## SERVICE BULLETIN

**APPLICABILITY:** 2019-23MY Crosstrek PHEV

**NUMBER:** 03-95-24

**SUBJECT:** Rear Differential Carrier / Design Change

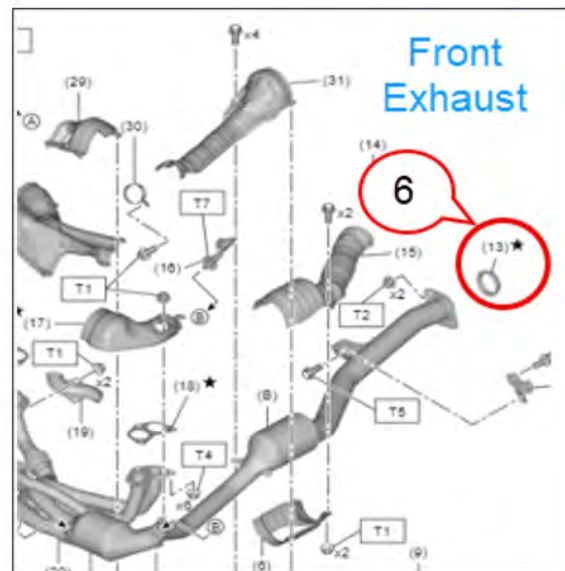
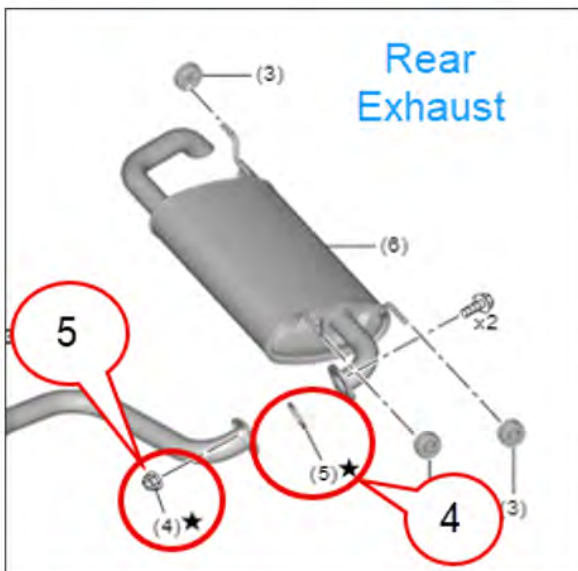
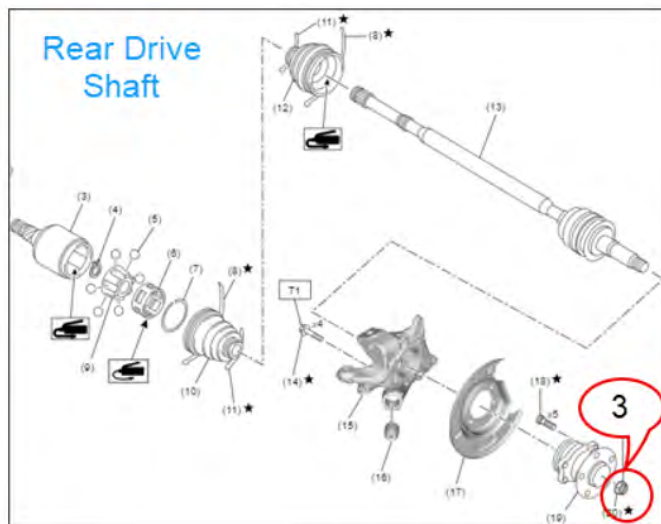
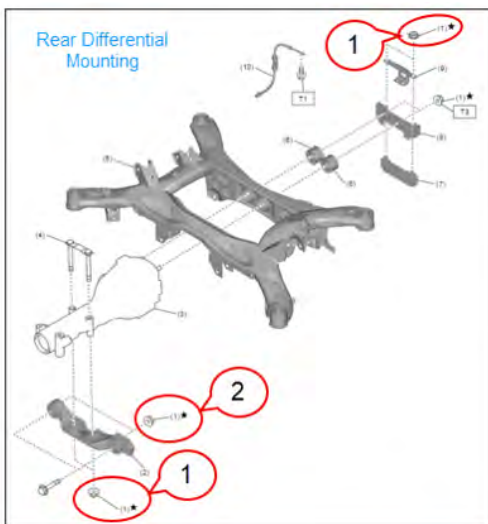
**IMPORTANT:** This procedure replaces a “VA” type rear differential to a “VB” type. 2019MY and 2020MY Service Manuals do not include the procedure for VB type rear differential.

**For 2019-20MY vehicles:** Always refer to 2021MY or later Service Manual in STIS: Driveline/Axle > DIFFERENTIALS > Rear Differential (VB-type)

**For 2021-23MY vehicles:** Always refer applicable Service Manual in STIS: Driveline/Axle > DIFFERENTIALS > Rear Differential (VB-type)
